**Medway DPW Water Quality Treatment  
Facility Site Plan – 19 Populatic Street**

**SUBJECT: Populatic Water Treatment Plant – Major Site Plan Review  
19 Populatic Street, Medway, Massachusetts**

Wright-Pierce has received Tetra Tech's comments on the Major Site Plan Review submission for the Populatic Water Treatment Plant project. We have prepared the following letter and attachments in response to these comments.

DRAWING  
C-3

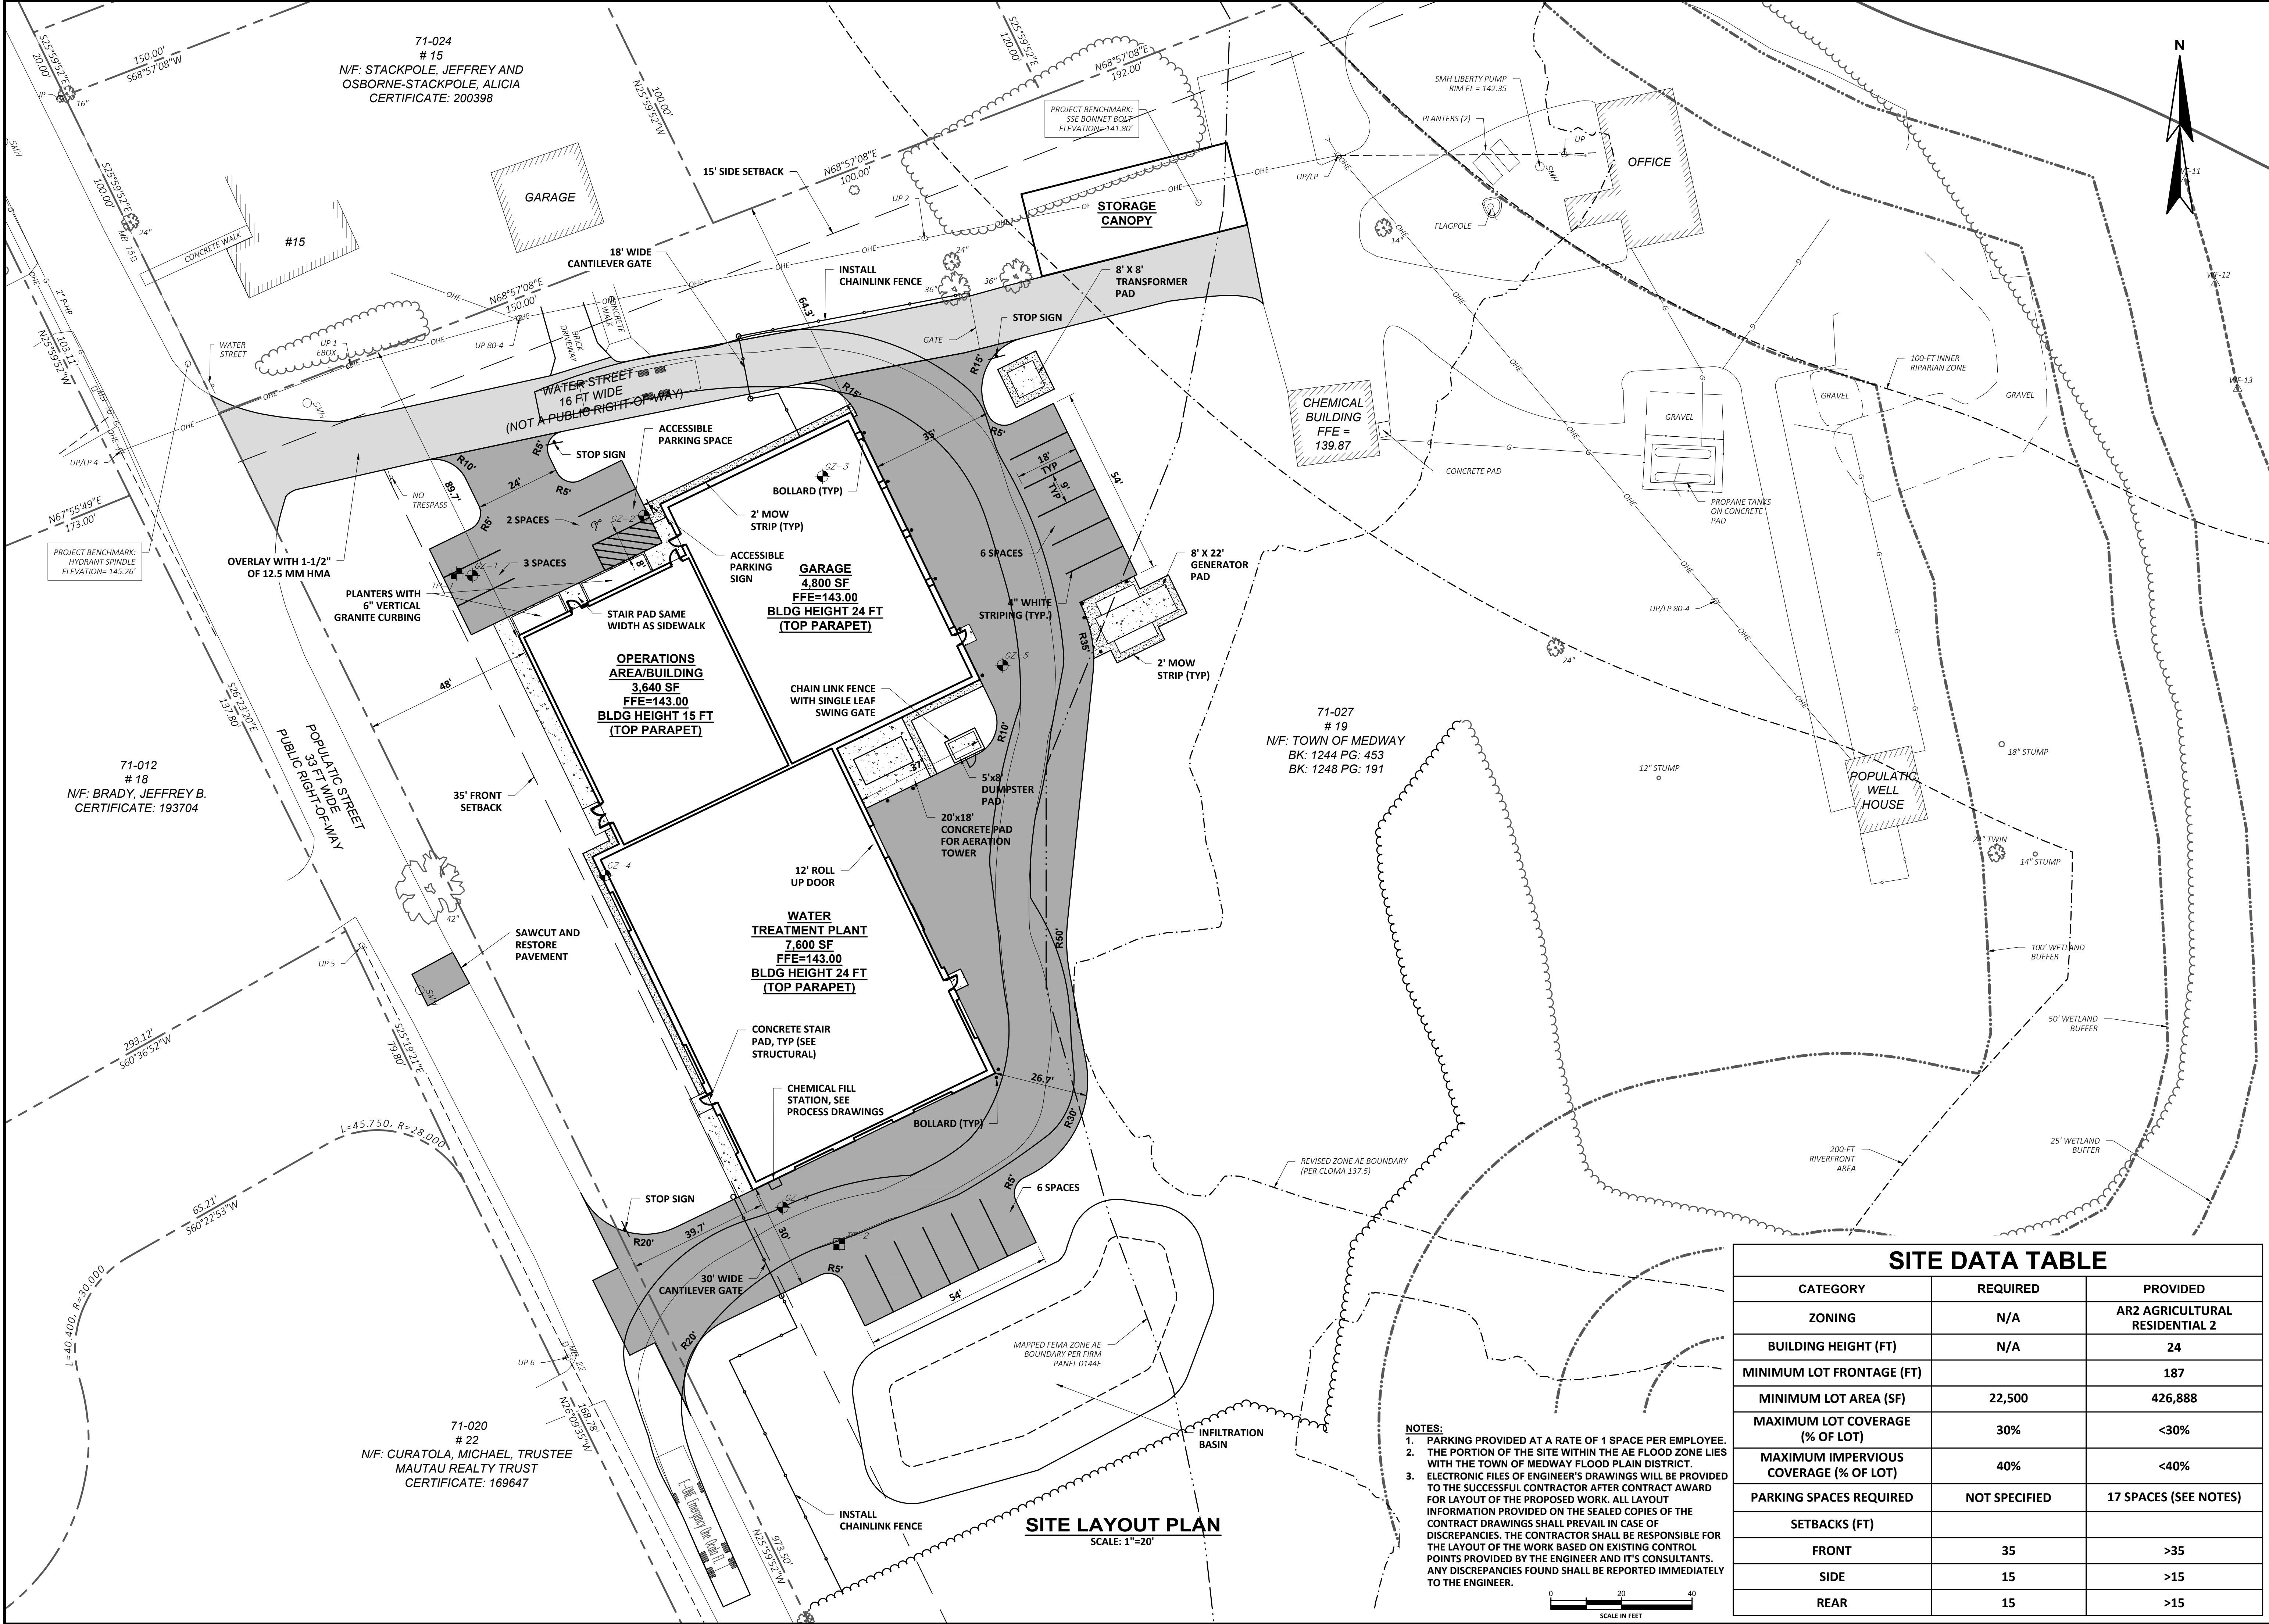
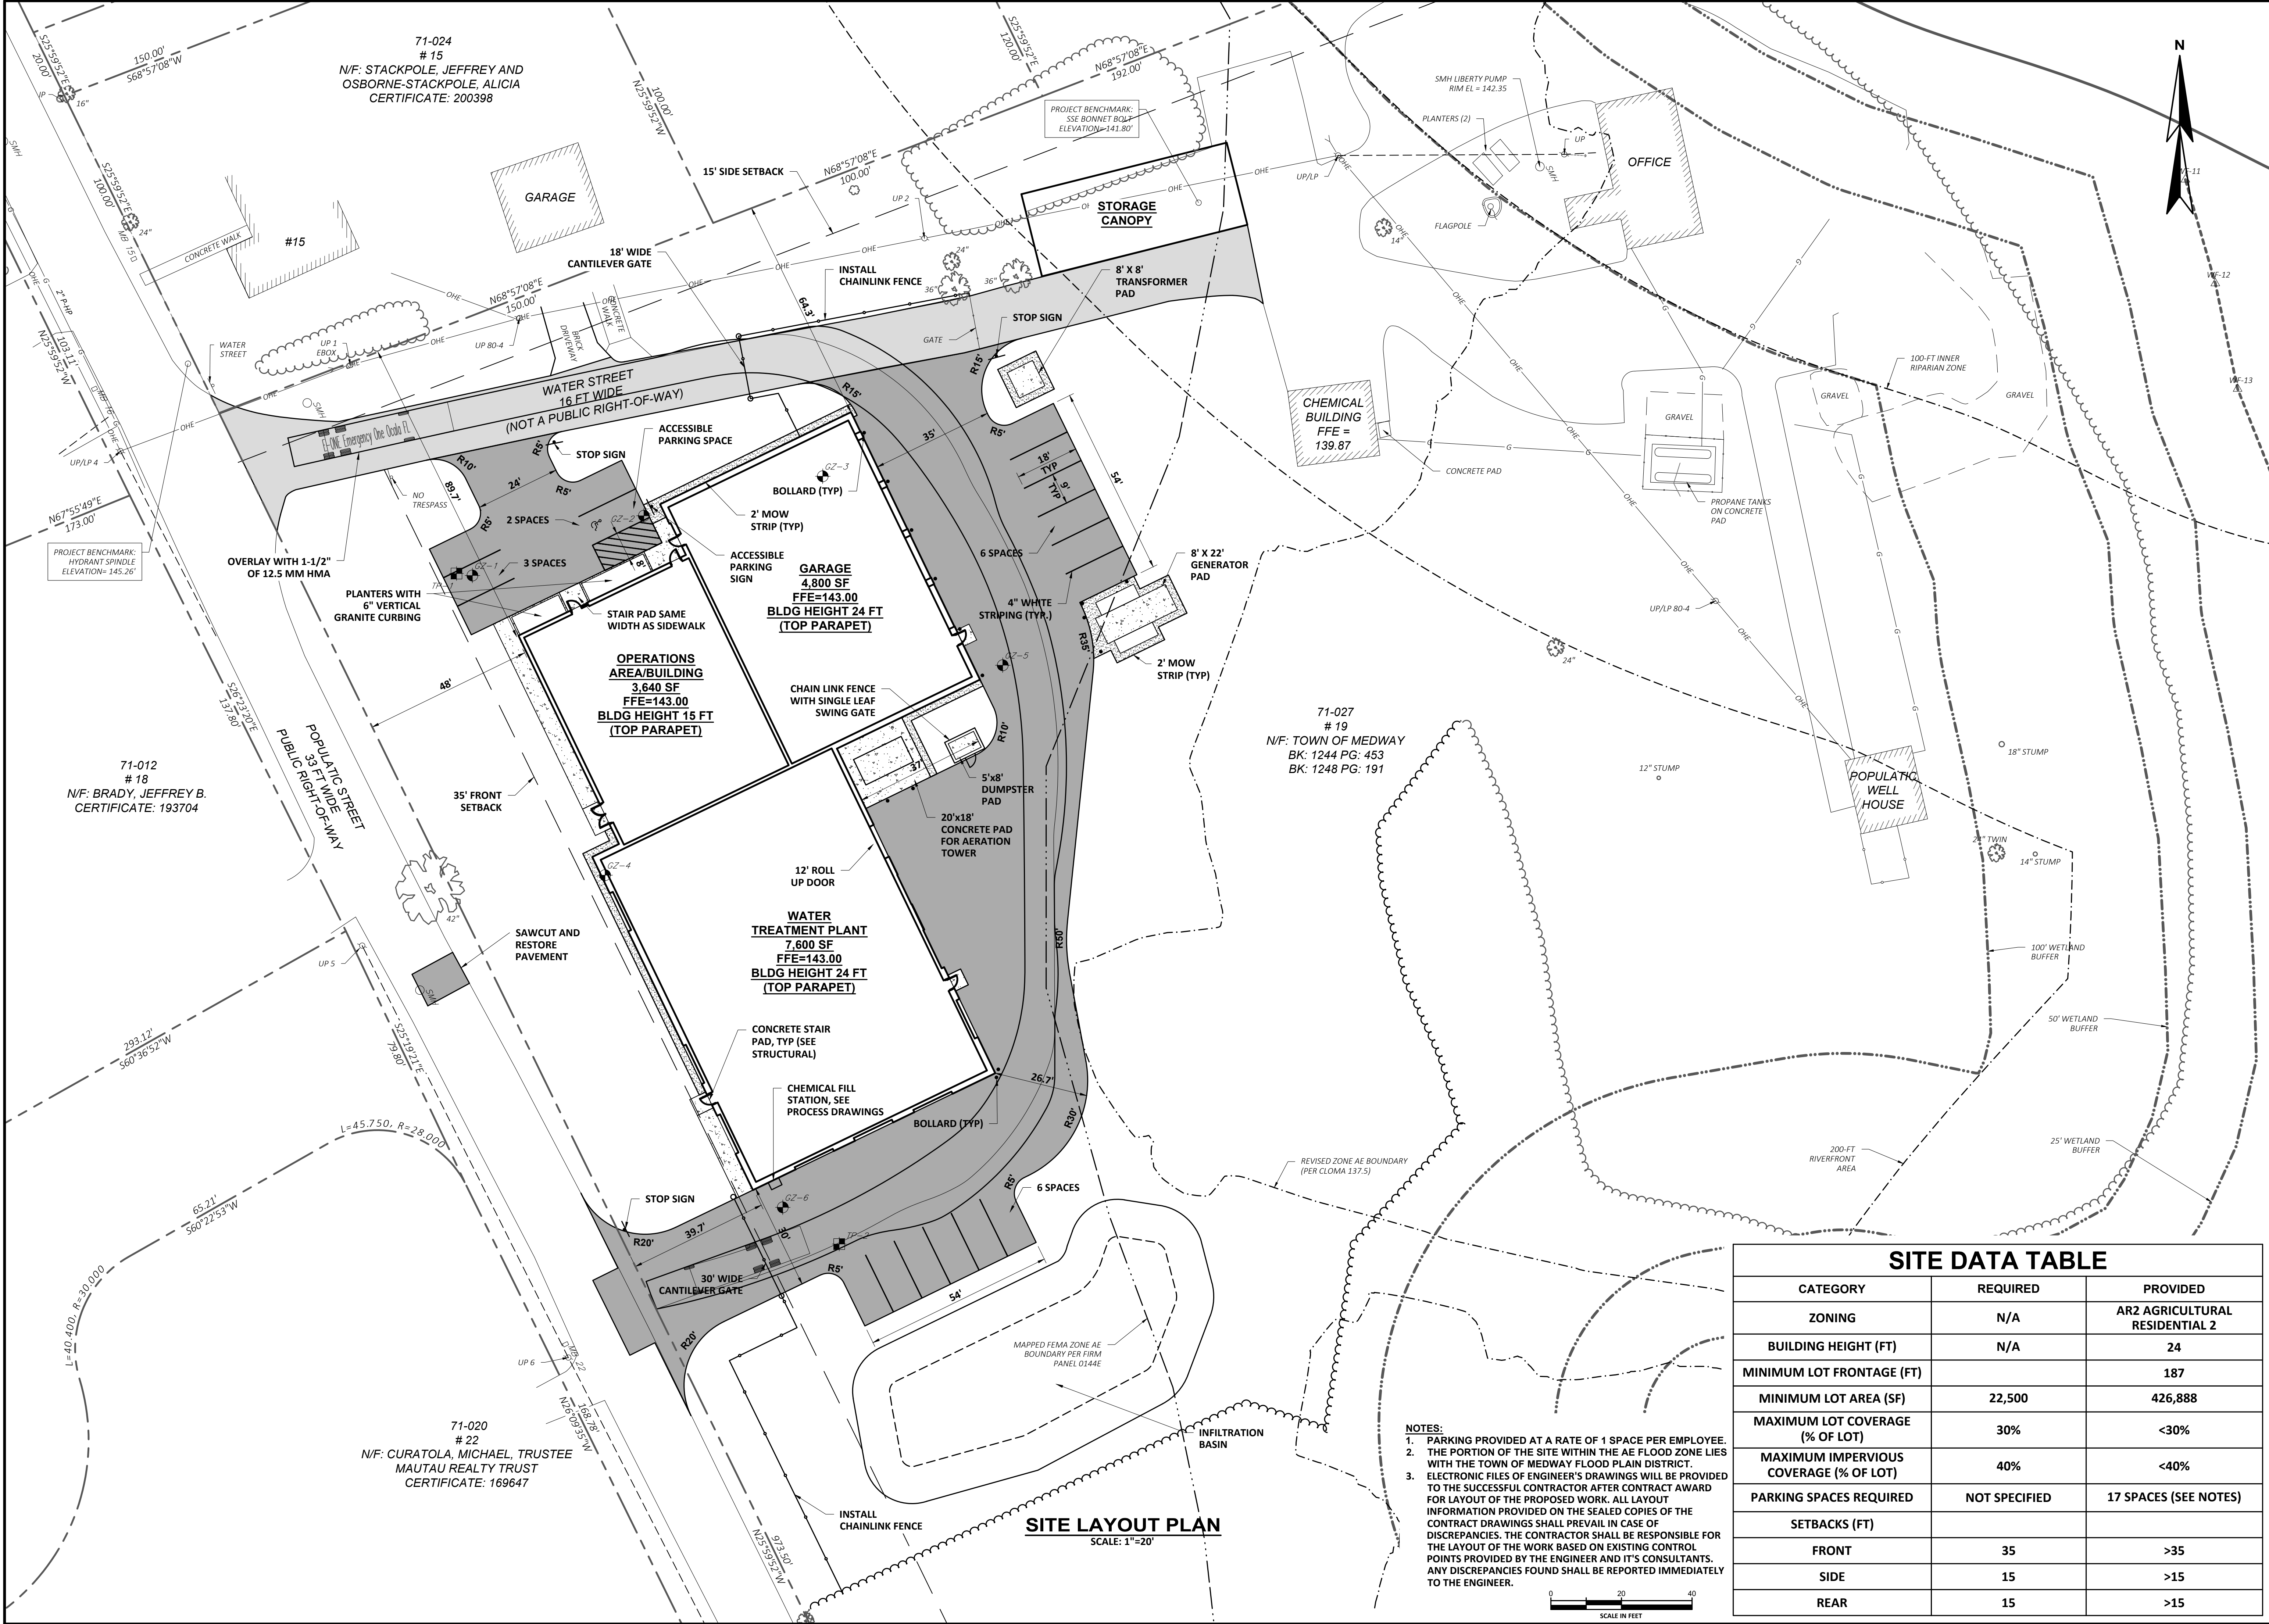
9. Front setback line is shown on the Layout Sheet, however, both side and rear setbacks are not represented and shall be included on the Plans. (Ch. 200 §204-5.D.1)

15. Horizontal site distances at the site driveways are not provided in the Plans. (Ch. 200 §204-5.D.16)

16. A table representing conformance with Zoning Bylaw requirements is provided on site Layout sheet. However, the table is missing minimum lot frontage and maximum building height. TT recommends proposed values be provided rather than "less than" or "greater than" symbols. (Ch. 200 §204-5.D.17)

***Response: Side and rear setback lines have been added to sheet C-3 in the revised drawing set. Refer to Attachment C.***

*Response: Horizontal site distances of greater than 200-feet were confirmed in the field at the new driveway location and they exceed the minimum of 155 feet in both directions for a speed limit of 25 mph. The site distances have been included on sheet C-3 in the revised drawing set. Refer to Attachment C.*

*Response: The Site Layout Sheet (C-3) has been updated in the revised drawing set to include the missing lot frontage and maximum building height. Refer to Attachment C.*
